ADDENDUM NO. 3

DATED: November 14, 2024

PROJECT:	WSD New Sr. High School	**DATE:**	11/14/2024
OWNER:	Wynne School District	**PROJECT NO:**	A-23010
TO:	Gary Hoyt Nabholz Construction	**CONTRACT FOR**:	General Construction

1 FOUNDATION PLAN - AREA B

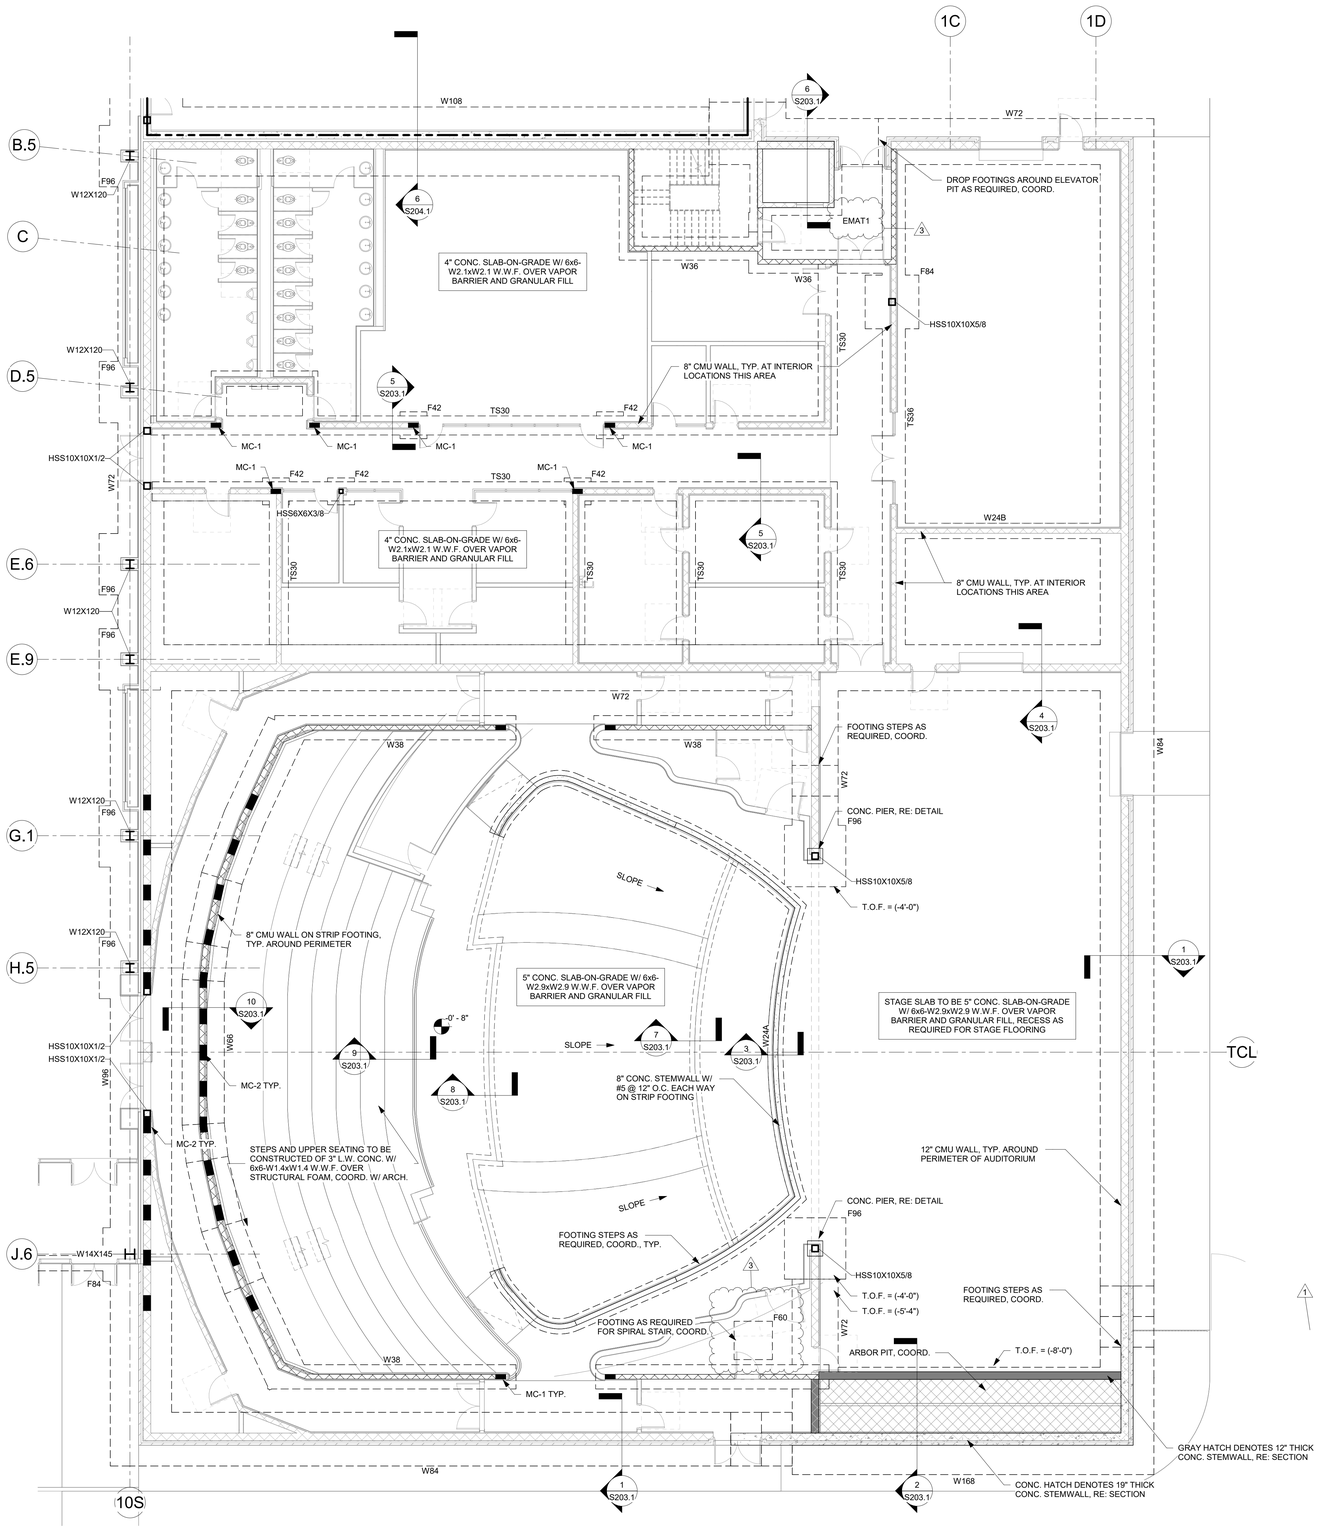
84. Sheet S101.2 FOUNDATION PLAN – AREA A SOUTH: Drawing has been updated and revised as indicated on drawing sheet.
85. Sheet S101.3 FOUNDATION PLAN – AREA B: Drawing has been updated and revised as indicated on drawing sheet.

SHEET NUMBER
S104.1

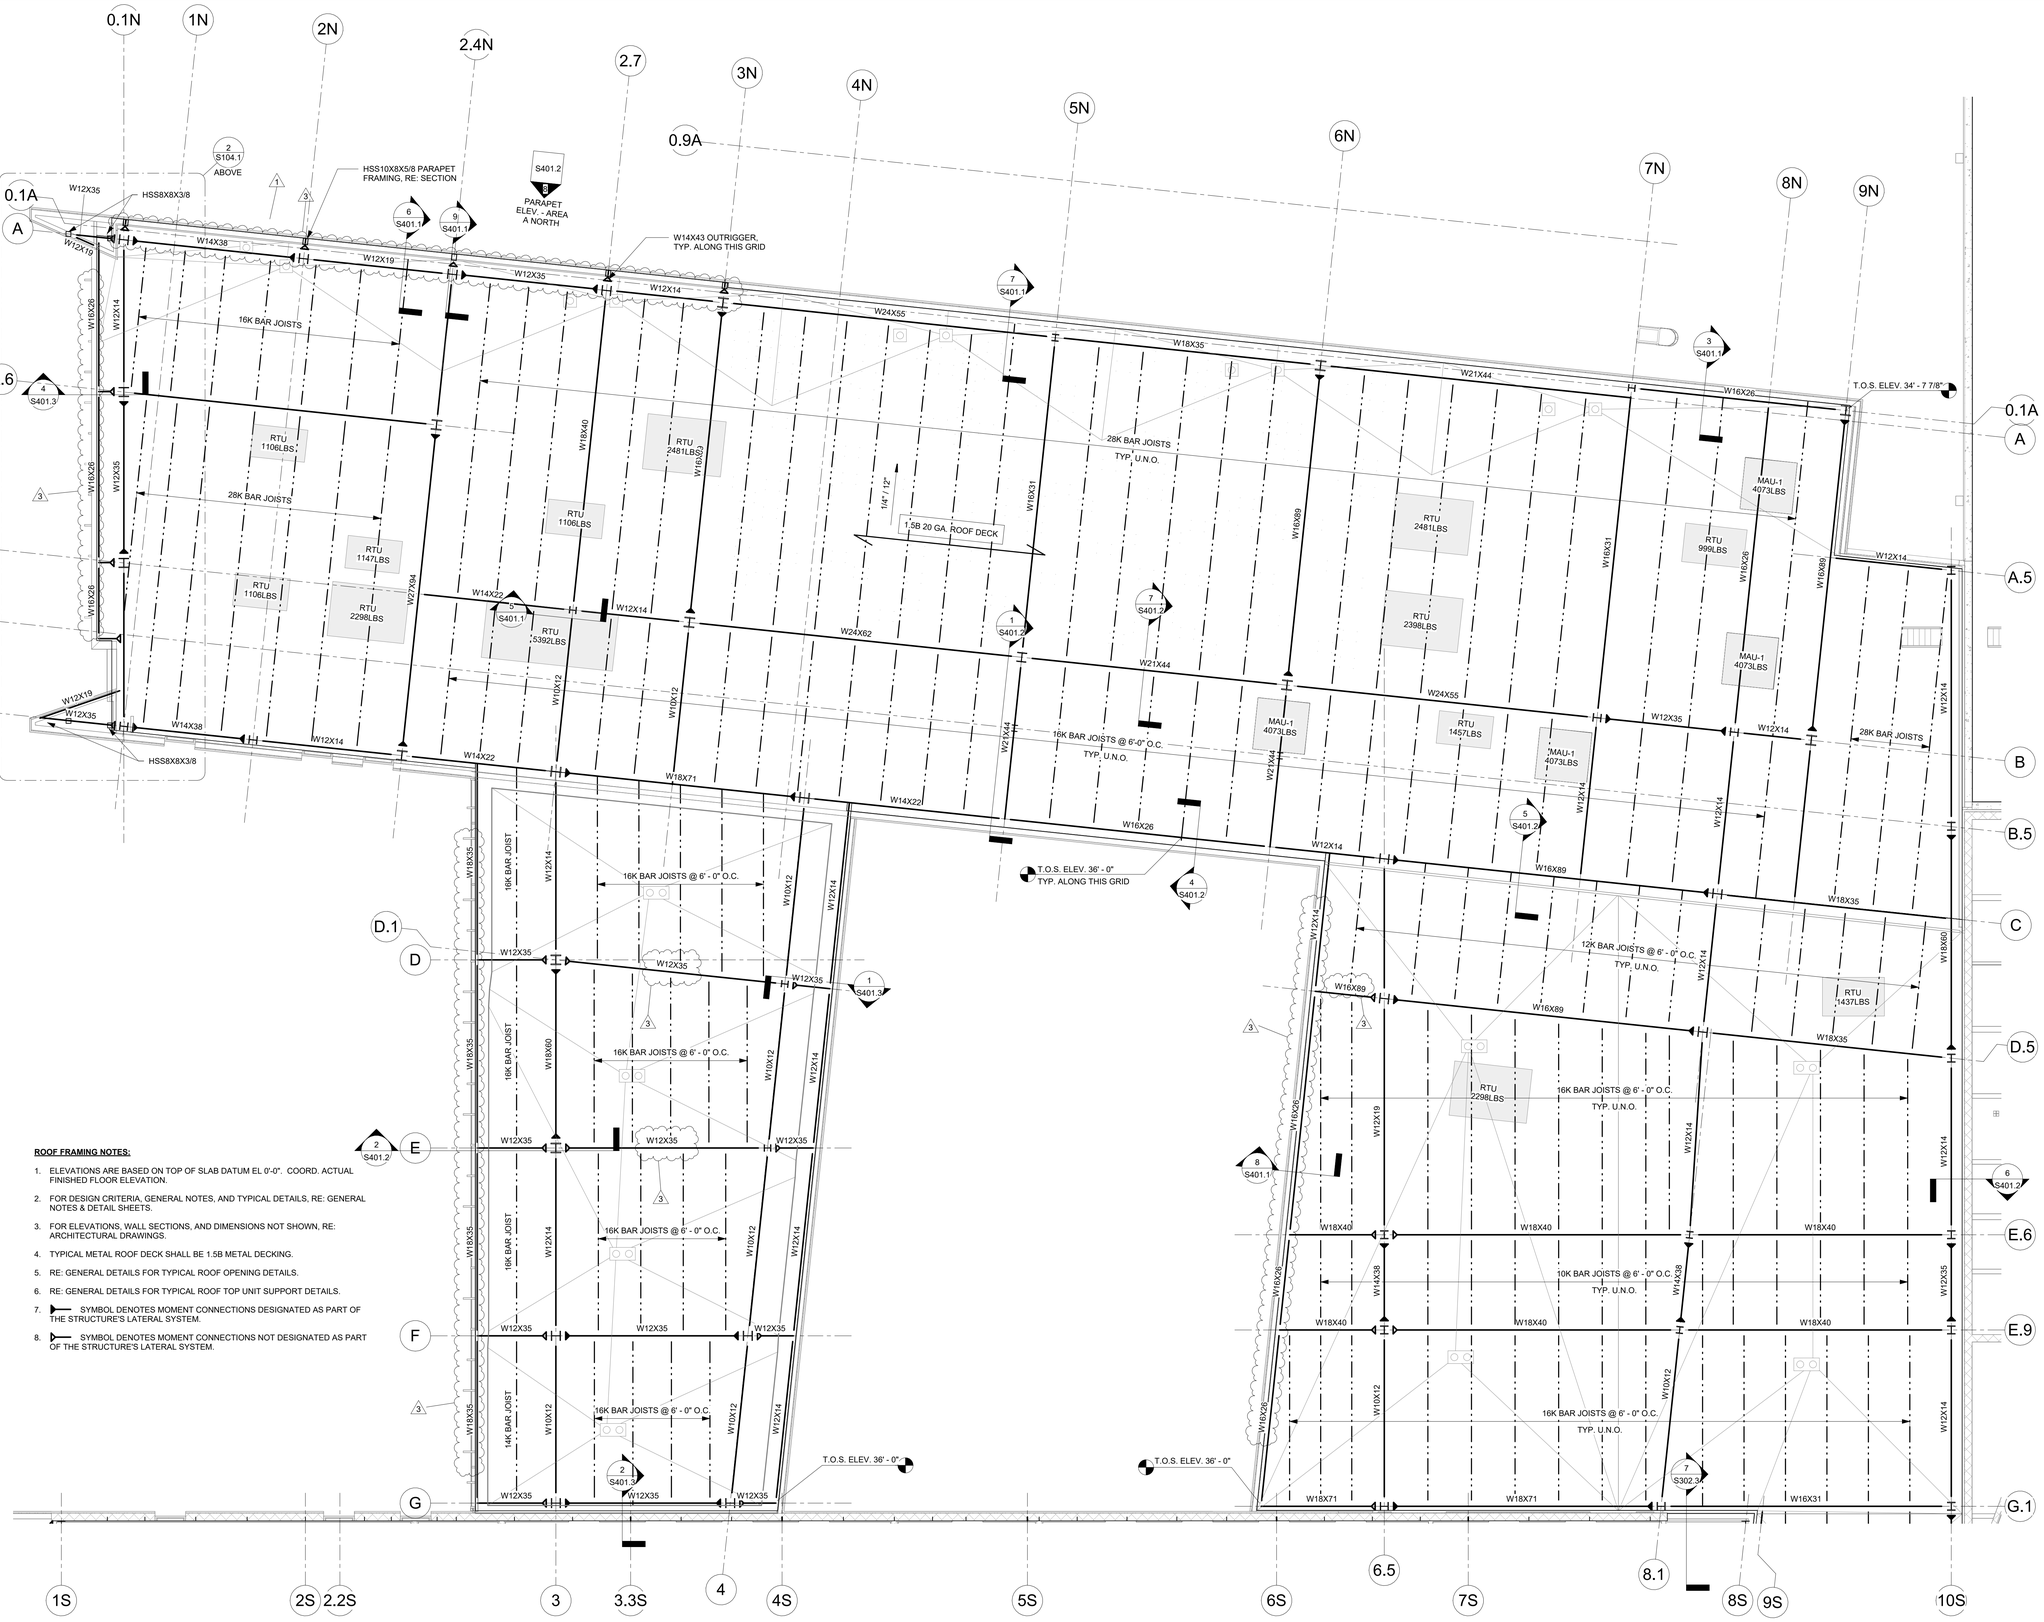
88. Sheet S104.1 ROOF FRAMING PLAN – AREA A NORTH: Drawing has been updated and revised as indicated on drawing sheet.
89. Sheet S104.3 ROOF FRAMING PLAN – AREA B: Drawing has been updated and revised as indicated on drawing sheet.

SHEET NUMBER
TC 101

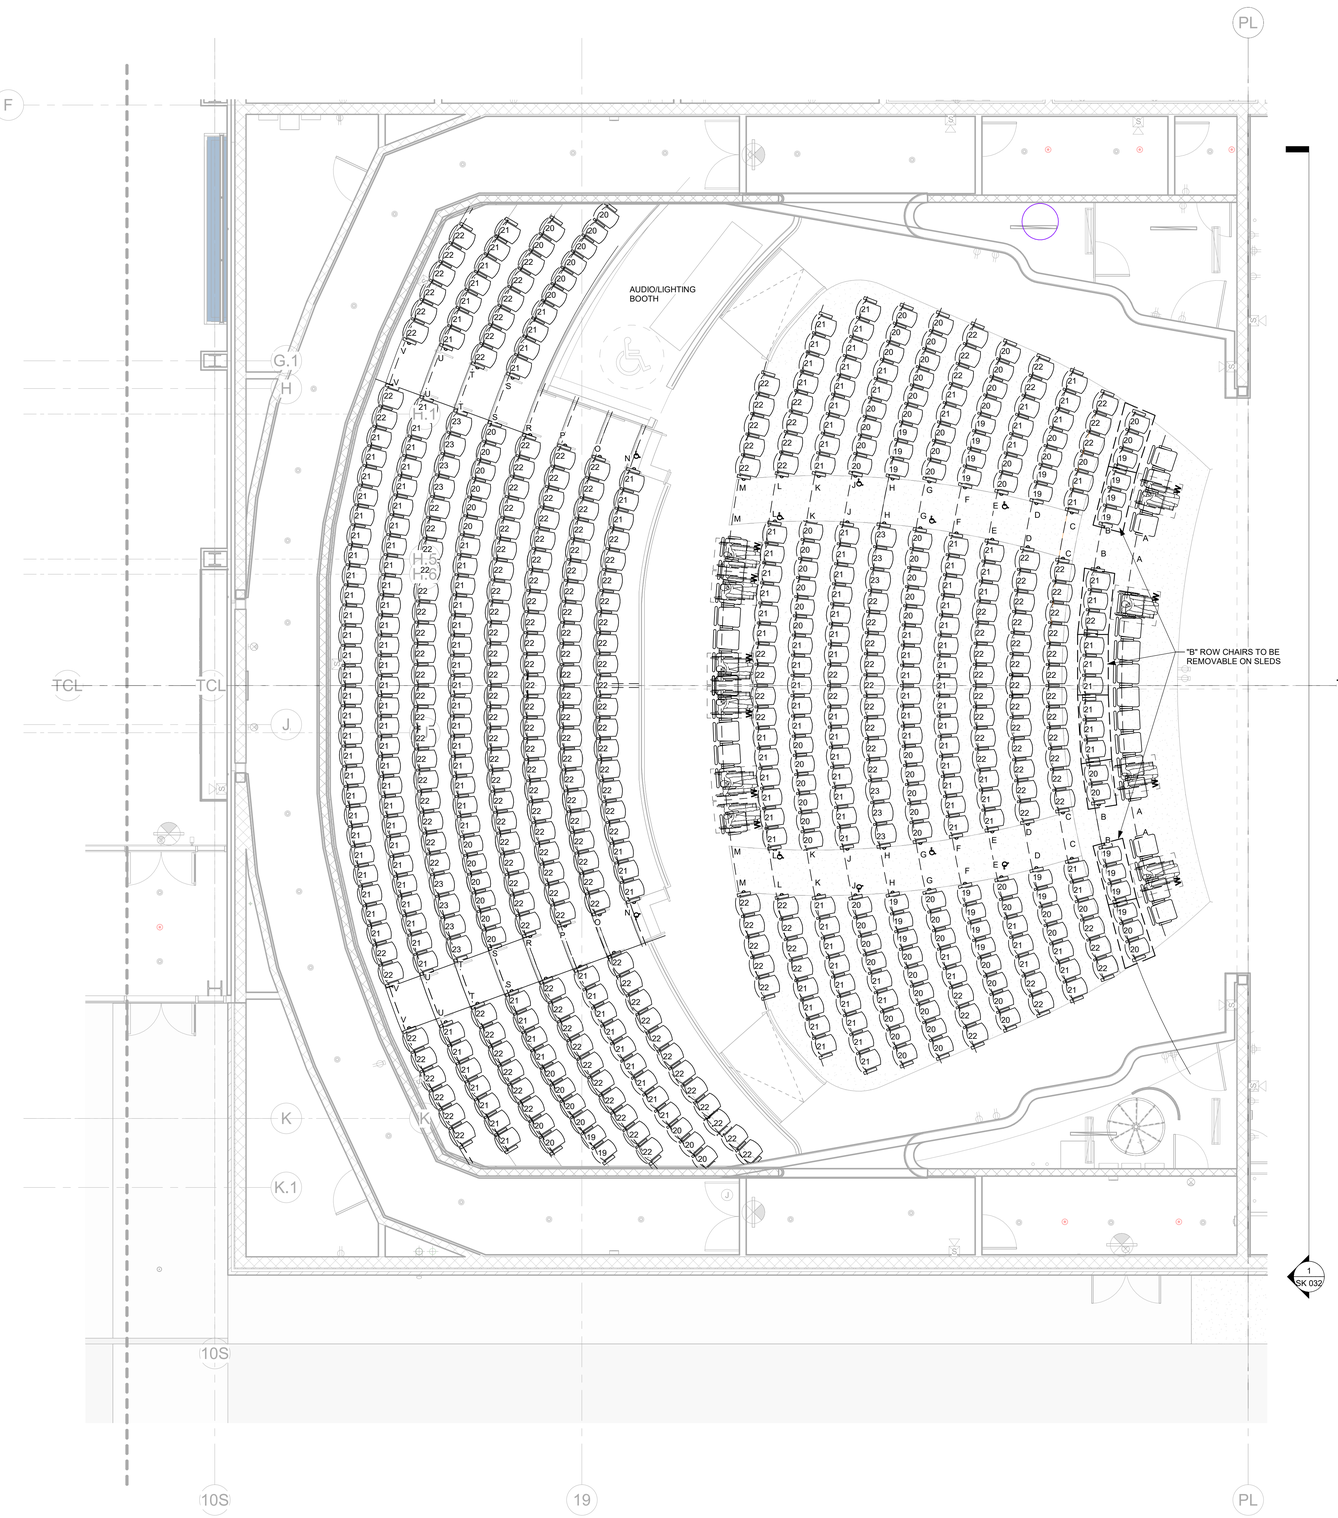
73	Pg c1.04 Dumpster enclosure without gates on north side of bleachers, Are gates a requirement?	Nabholz	This item was deleted
80	PLEASE CONFIRM SEAT COUNTS, AS THEY VARY FROM DRAWING SHEETS TC 101 & TC 102 AND SKE 004. WHICH SEAT COUNTS ARE CORRECT? DRAWINGS ARE ATTACHED.	MISSCO	Design revisions are being made that effect this number.
82	Lint trap shown on details sheet P401, none shown on plumbing schedule or seen on plan. Please advise.	Comfort Systems USA	P401: Lint trap details have been omitted.
83	Booster pump shown on plan P101.4, none shown on plumbing schedule, please advise.	Comfort Systems USA	P001: Boosted Pump Schedule has been added.
84	MS-2 on plumbing scheduel repeats NFWH description on schedule, please advise.	Comfort Systems USA	P001: Plumbing Schedule updated.
85	No mixing valves specified for eye wash stations, please advise.	Comfort Systems USA	P101.2 & P103.2: See Plumbing Keynote Legend to mixing valve manufacturer and model number.
